Product hierarchy no. *			Part no.	SBU	Type / Description	Customer part no.
SBU   PG	PGU	Type				
02   006	017	0000001601	See list below	Power Entry Module with Filter	EF12

**2 Type of change**

New internal wiring.

EF12					0118.2264	
creation date	created by	release date	released by	notification no.	revision	page
2015-01-19	huberth	2015-08-05	huberth			1 of 2

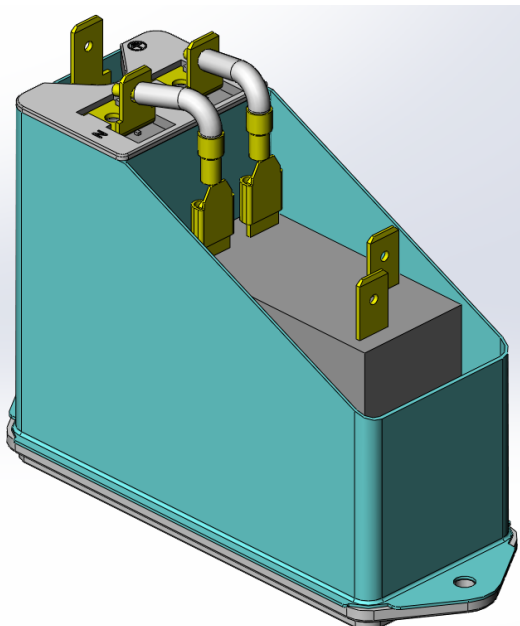
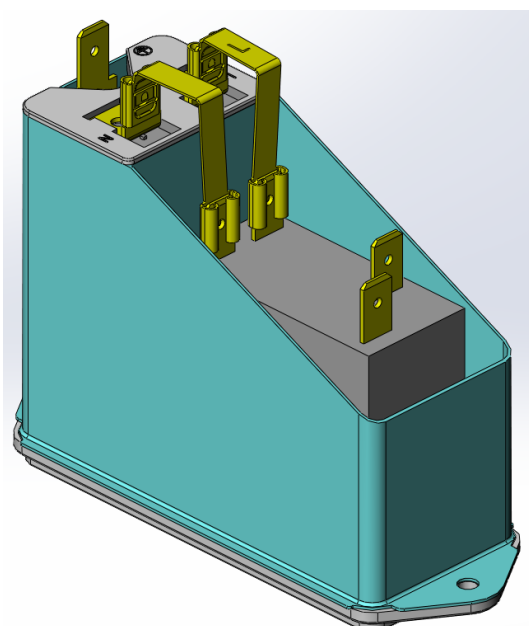
Soldered wire connection between filter and circuit breaker replaced by faston connection.

Elimination of the critical soldering process on the quick connect terminal.

Form: Yes New connection on back side, no change of outer dimensions.  
Fit: No There are no dimensional changes.  
Function: No This is a non-functional change.  
Production Site: No There is no change of the production site.  
Product Label: No There is no change on the label.
